Sub Regional RTEP Committee: Western DEOK Supplemental Projects

Changes to the Existing Projects

DEOK Transmission Zone S1782 Additional Scope

Process Stage: Solutions Meeting 12-16-2022

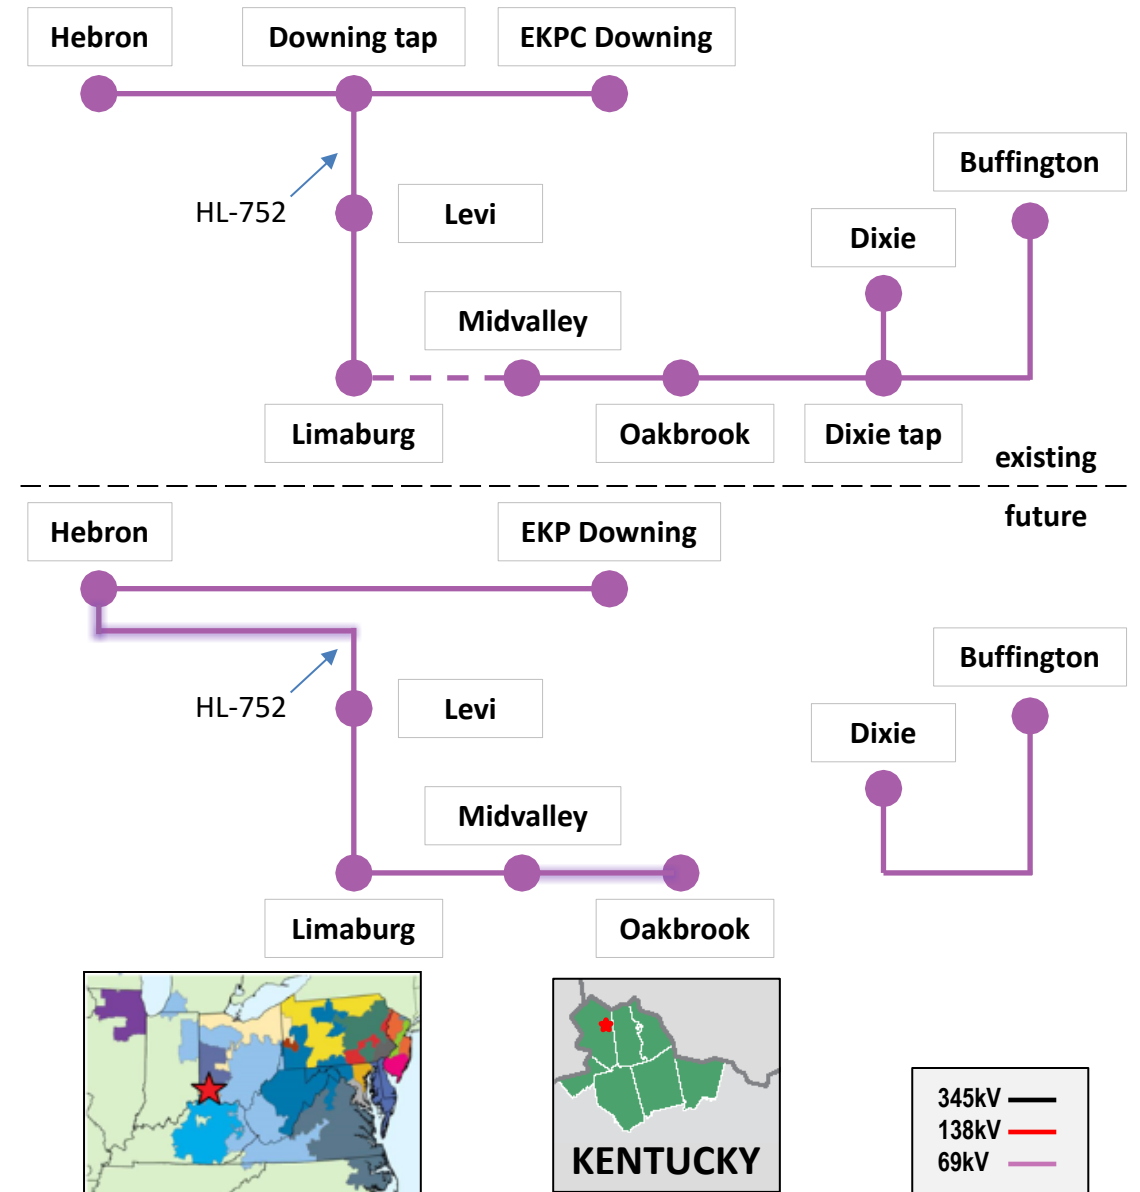
Subsequent to submitting the Aero/Woodspoint project (DEOK-2018-001, s1782) to the 2019 Duke Energy Local Plan, a thermal violation was found on the 69 kV circuit from Buffington to Oakbrook for the loss of the 138 kV circuit from Aero to Woodspoint. Need DEOK-2020-001 addressed this violation in the February 2020 PJM Subregional RTEP-Western meeting. Analysis by PJM found that the violation occurred with incremental loading from the Aero/Woodspoint project and was not tied to the load growth from DEOK-2020-001. PJM advised that need DEOK-2020-001 should be withdrawn and any scope to address the Buffington to Oakbrook violation be amended the solution for the Aero/Woodspoint project. Need DEOK-2020-001 was withdrawn in the April 2020 PJM Subregional RTEP-Western meeting.

At Hebron substation expand the box structure and install two new 69 kV, 2000A breakers to create a 4-position ring bus with individual positions for a circuit to Downing and a circuit to Oakbrook. Retire a feeder section from Downing tap to structure HL-752 (0.67mi.). Construct a new section of feeder from Hebron to structure HL-752 with 954 ACSR on steel poles (1.75 mi.). Raise two other circuits on shared structures in the corridor near the former Downing tap to allow the new feeder to pass under. At Levi replace 500 MCM strain bus with 954 ACC conductor, remove bus tie switch SW4250. Replace drops into and out of Limaburg with 954 ACSR conductor. At Limaburg replace 500 MCM strain bus with 954 ACC conductor, remove bus tie switch SW610, close normally open switch SW620 to complete the circuit to Oakbrook. Rebuild the section of feeder from Midvalley to Oakbrook with 954 ACSR on steel poles (1.5 mi.). Retire a feeder section from Oakbrook to Dixie tap (5.70mi.). The ratings on the circuit from Hebron to Oakbrook will increase from 54/54 MVA to 133/133 MVA, S/N/E, and from 69/69 MVA to 166/166 MVA W/N/E. (**S1782.1**)
